## North York Community Council

**From:** wilfred Lindo <wilfred.lindo@sympatico.ca>  
**Sent:** September 29, 2020 9:56 AM  
**To:** North York Community Council  
**Cc:** Doug Stiles  
**Subject:** FW: Questions and Concerns re 755 Steeles Development Proposal, Village Residents and Ratepayers Association  
**Attachments:** Signatures from residents opposing 755 Steeles West development proposal.pdf; Questions and Concerns re 755 Steeles developmet proposal, Village Residents and Ratepayers Association.docx  
**Importance:** High  
**Follow Up Flag:** Follow up  
**Flag Status:** Flagged

Our Village Residents and Ratepayers Association has questions and serious concerns regarding the Development Proposal of 755 Steeles Avenue West - Zoning By-law Amendment Application, Ref. #14 248860 NNY 10.

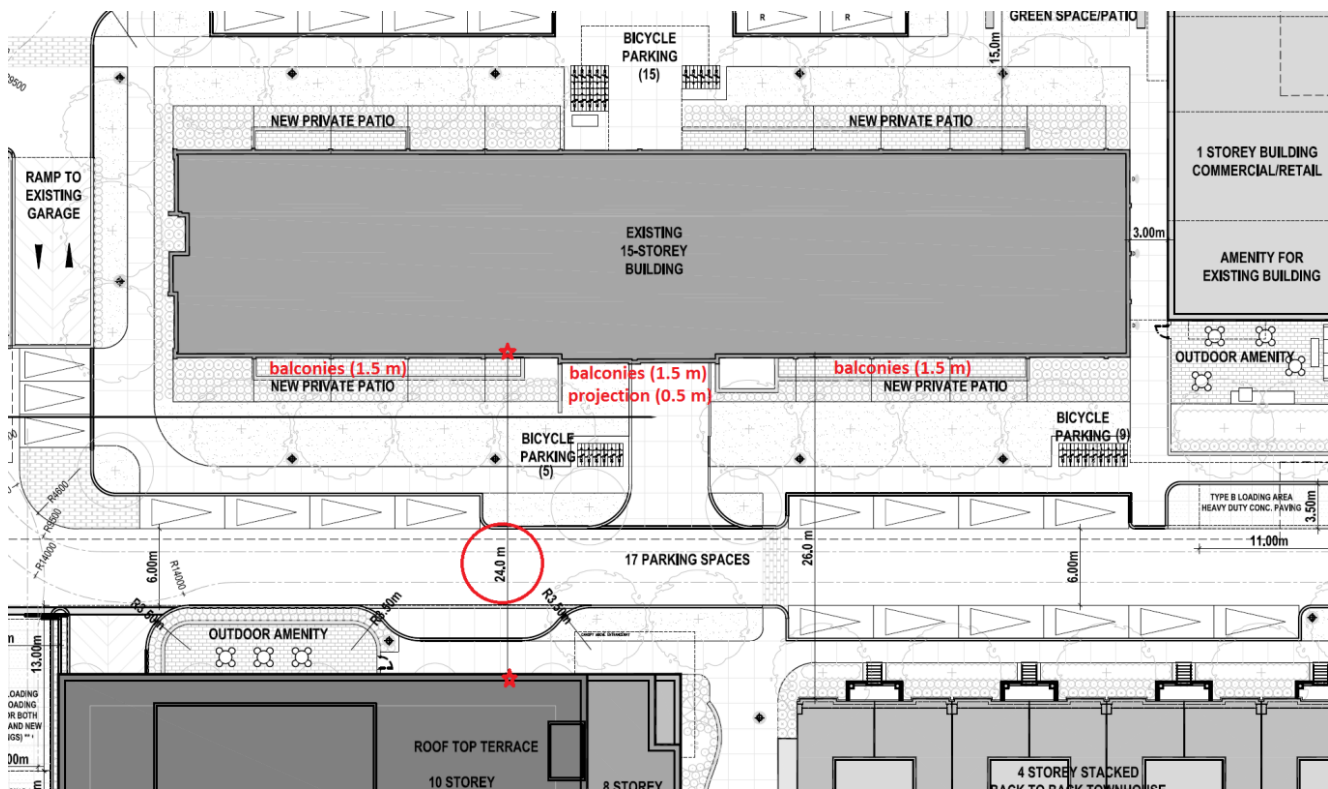
As per the Architectural Plan, resubmitted by the Developer on May 27, 2020, the separation distance between the existing 15 storey building at 755 Steeles Ave W. and the proposed 10 storey building is 24.0 m. Please note that the Architectural Plan indicates 24.0 m as a distance between the two walls of both buildings.

The existing 15 storey apartment building at 755 Steeles Avenue West has balconies on the north and south sides. The Architectural Plan represents the apartment building without balconies. Each balcony at 755 Steeles protrudes 1.5 m and is considered to be *a portion of the building*. This reduces the separation distance between the existing and proposed buildings to 22.5 m.

The Architectural Plan indicates a projection in the center of the south side of the apartment building. The projecting part of the building also has balconies on it. The depth of this projection is 0.5 m that will bring the separation distance between this portion of the apartment building and the proposed building to 22.0 m.

Please note that the proposed 10 storey residential building is also planned to have balconies (please refer to the Architectural Plan, p. 10-19), that will further reduce the 22.0 m separation distance. Below is an extract from the Architectural Plan (p. 2) with our annotations in red:

The abovementioned Architectural Plan indicates a 3.0 m separation distance between the existing 15 storey apartment building and the proposed 1 storey commercial building.

**Question: Is the proposed architectural plan in compliance with the Building Code Act as the latter pertains to the separation distance between the existing apartment building and the proposed 10 storey residential and 1 storey commercial buildings?**

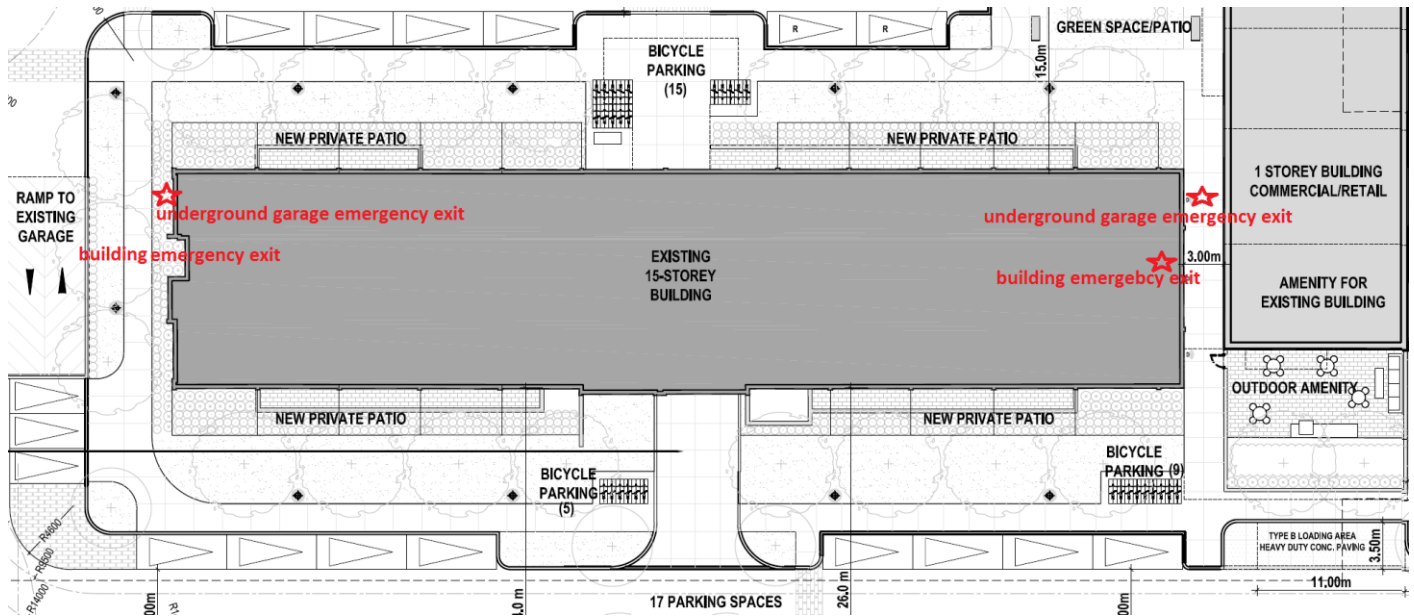
Please note that the existing 15 storey apartment building has an emergency exit door on the east side of the building and the emergency exit from the underground garage on the same side of the building, as well as another garage emergency exit on the west side. Neither of these openings are indicated by the Developer in the abovementioned Architectural plan. (Please refer to annotated plan below).

**Question: If the existing emergency exits are not indicated on the plan (marked with a star), does this mean that the Developer is planning to eliminate existing emergency exits?**

**Question: As there are no emergency exits indicated in the existing 755 Steeles Ave W. apartment building on the proposed plan, does this pose fire and/or other safety hazards should this plan be adopted? If it does not, please explain why. Does this pose fire and/or other safety hazards should there be any people present in the underground garage in case of fire or any other emergency? If it does not, please explain why.**

Please see a photograph of the east side of the existing apartment building at 755 Steeles Ave West with the 2 existing emergency exits not indicated on the proposed plan. Please note the length of the underground garage emergency exit is 4.00 m:

**Question: Provided that the 4.0 m underground garage emergency exit is preserved, how would the proposed commercial building be constructed in accordance with the architectural plan indicating a 3.0 m separation distance?**

**Question: Does the 3.0 m separation distance from the proposed commercial building create a safety hazard for the residents of the existing 194-unit apartment building in case of evacuation in an emergency situation? If it does not, why?**
